Appendix 4.2 ECU Scoping Opinion

KNOCKCRONAL WIND FARM i Appendix 4.2

Scoping Opinion on behalf of Scottish Ministers under the Electricity Works (Environmental Impact Assessment) (Scotland) Regulations 2017

Knockcronal Wind Farm ITPEnergised On behalf of Statkraft Ltd

Figure 1: Proposed development location shown on an airways chart

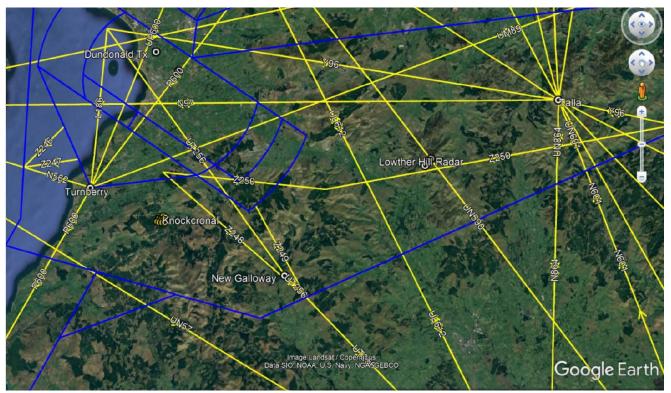
Unit or role	Comment
Prestwick ATC	Unacceptable
